**TOWN OF NEWBURGH
PLANNING BOARD
TECHNICAL REVIEW COMMENTS**

PROJECT NAME: ANCHORAGE-ON-THE-HUDSON LOT #3
PROJECT NO.: 23-06
PROJECT LOCATION: SECTION 121, BLOCK 1, LOT 3
REVIEW DATE: 28 OCTOBER 2024
MEETING DATE: 7 NOVEMBER 2024
PROJECT REPRESENTATIVE: ENGINEERING AND SURVEYING PROPERTIES

SITE PLAN

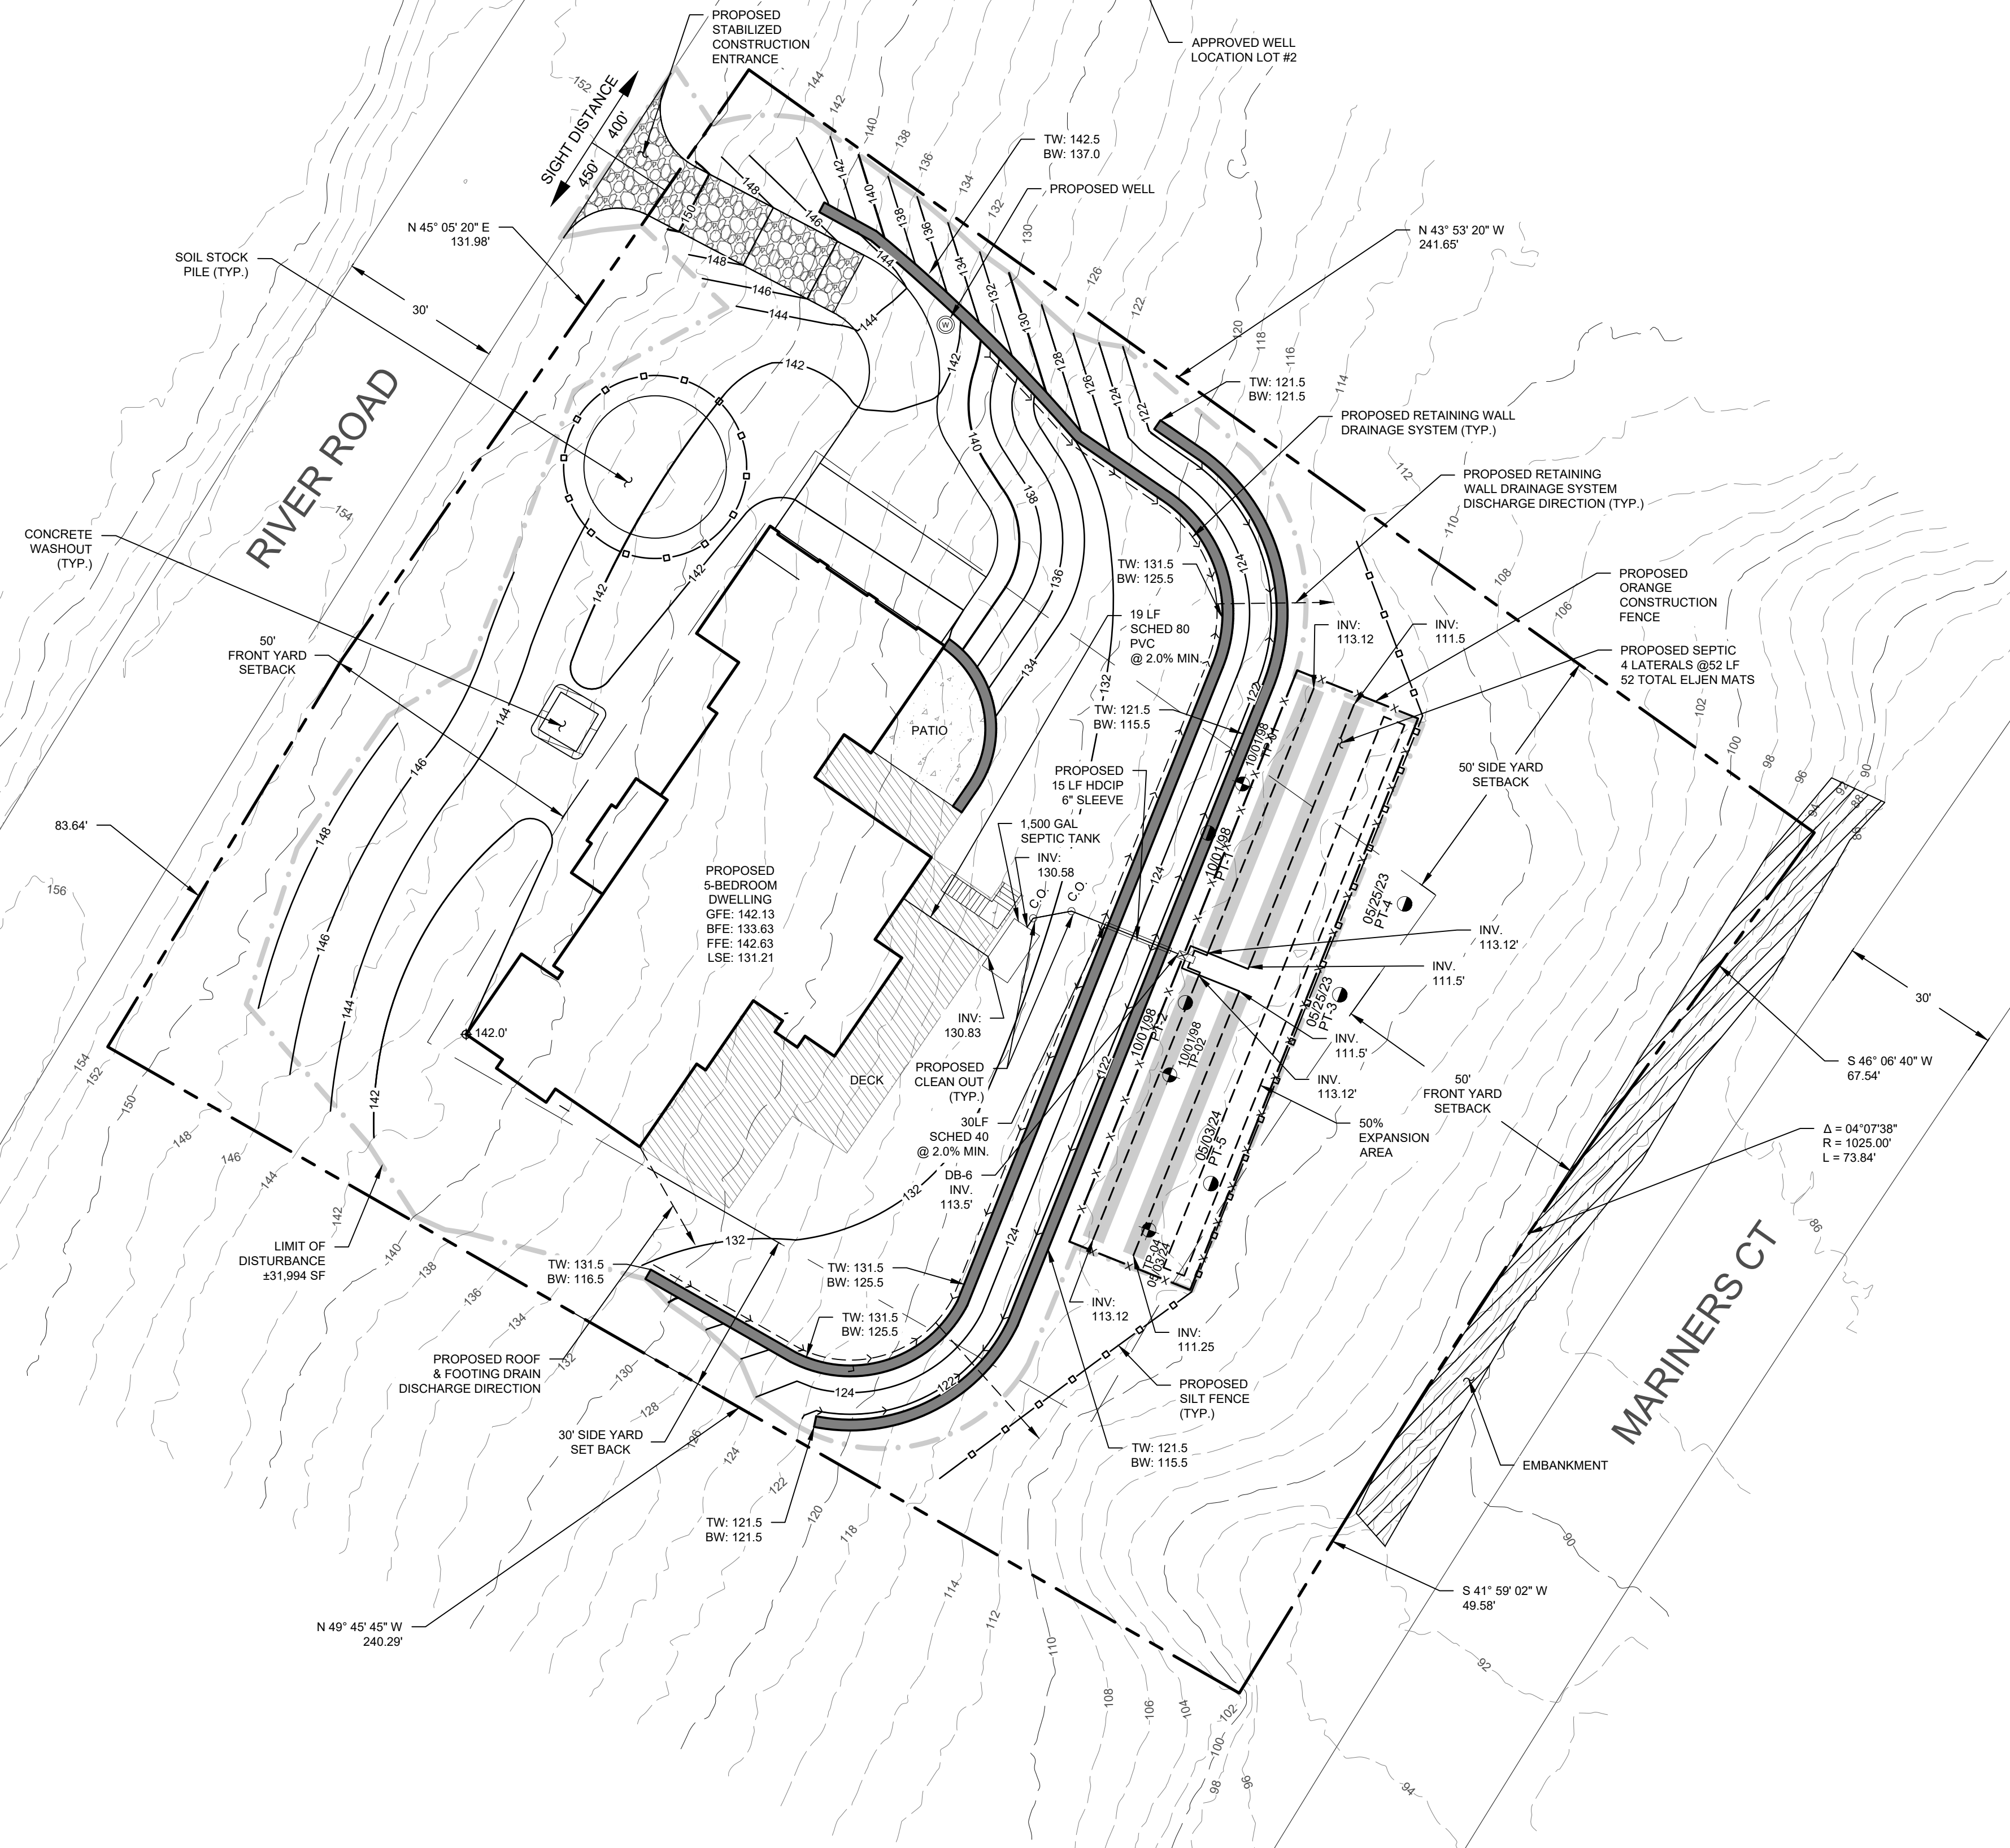
1. Additional erosion and sediment control details have been added to the plan.
2. Limits of disturbance have been depicted on the plan sheets. 32,000 +/- square foot of disturbance is proposed. This equals 0.73 acres of disturbance.
3. The project has received approval from the Orange County Health Department for the subsurface sanitary sewer disposal systems.
